Issuing Entity:	Bulletin No.: N-013-200312_00
Vekoma Rides Parts & Services B.V.	Release Date: 20-03-2012
Schaapweg 18	Effective Date: 20-03-2012
6063 BA VLODROP	Supersedes: -
The Netherlands	Completion Date: N.A.
CoC Number: 12049585

Notification

This notification describes preventive measures to minimize the possible risk of injury to passengers of a MK1205 train.

Figure 1: Add-on renderings

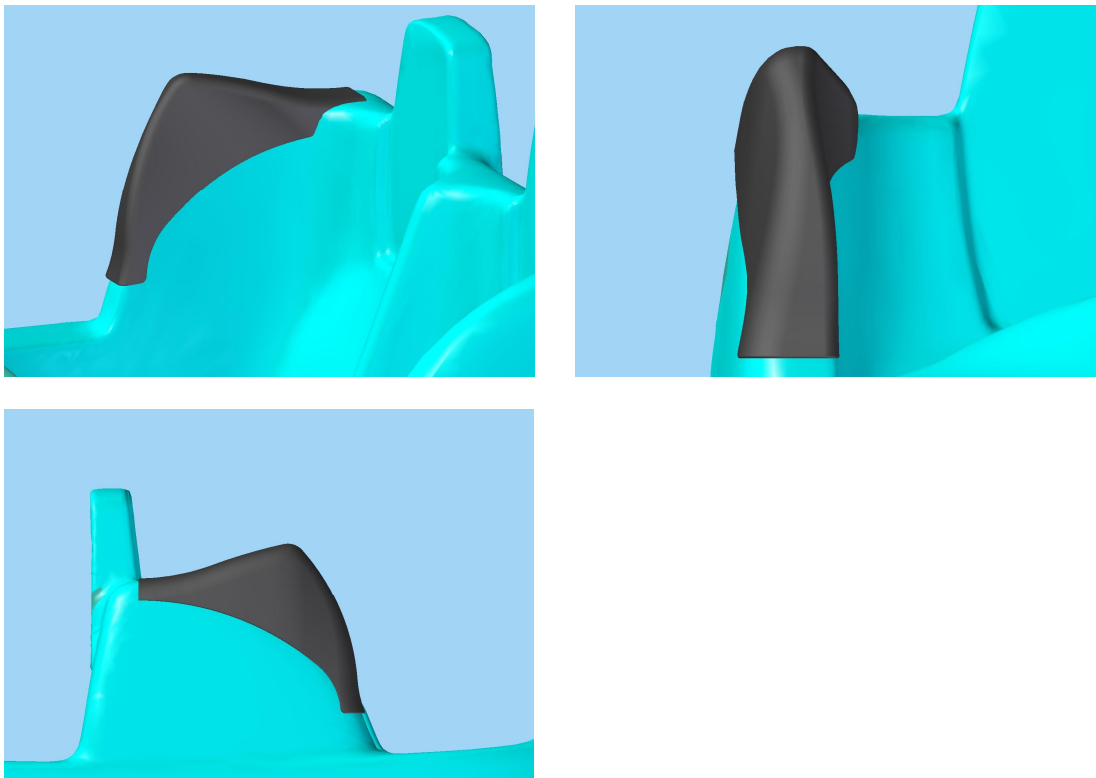
As mentioned in service bulletin SB-011-050810 there is the possibility that certain passengers of a MK1205 train could be able to reach outside of the coach with an arm and touch stationary objects to the side of the track. The service bulletin strongly recommends to apply warning stickers on each coach. Nevertheless, passengers are still able to reach outside of the coach.

For all affected serial numbers mentioned in Table 1, VRP&S has developed an add-on for the MK1205 train which results in a reach envelope (as defined by the latest ASTM 2291 standard for reach envelopes at issue date of this document) that is smaller than the initial clearance envelope of the ride. VRP&S recommends to equip the MK1205 train with the add-on (see figure 1).
